SUNDRY NOTICES AND REPORTS ON WELLS
(DO NOT USE THIS FORM FOR PROPOSALS TO DRILL OR TO DEEPEN OR PLUG BACK TO A DIFFERENT RESERVOIR USE "APPLICATION FOR PERMIT" (FORM C-101) FOR SUCH PROPOSALS)

CHEVRON U.S.A. INC. INTENDS TO TEMPORARILY ABANDON THE SUBJECT WELL.

Cole A # 9
Blinebery Oil & Gas Field
T22S, R37E, Section 16
Job: TA Well

Current Wellbore Diagram

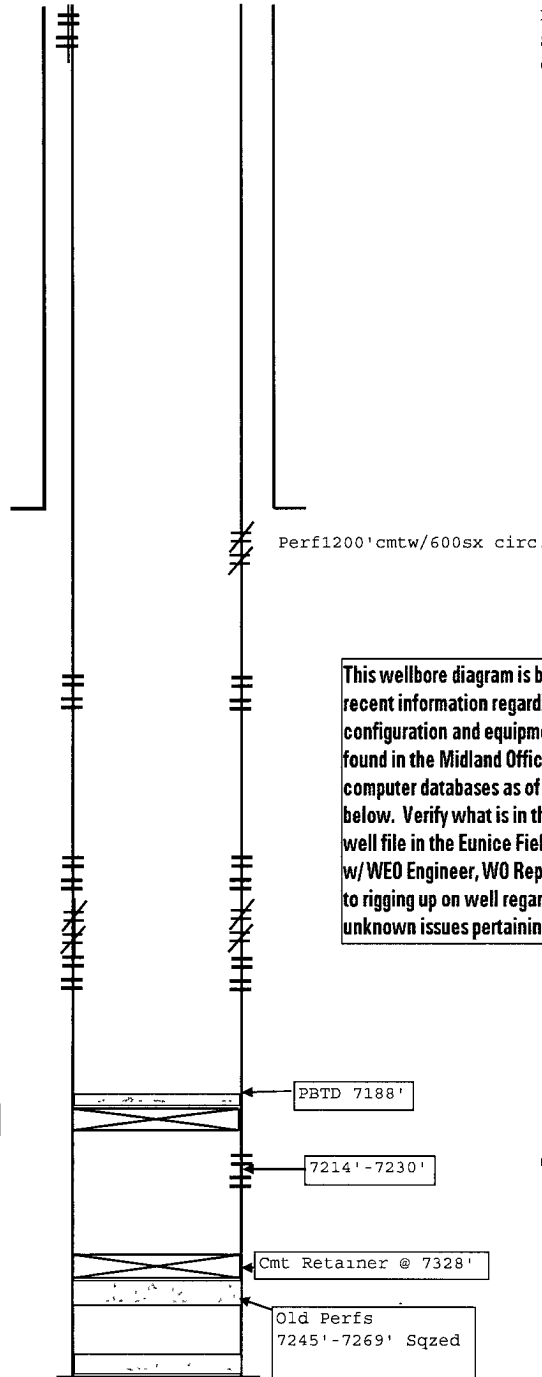
* Must have CIBP < 100' top of.

Spud Date: DRINKARD perfs. capped w/ 35' cmt.

Condition of Approval: Notify OCD Hobbs office 24 hours prior to running MIT Test & Chart
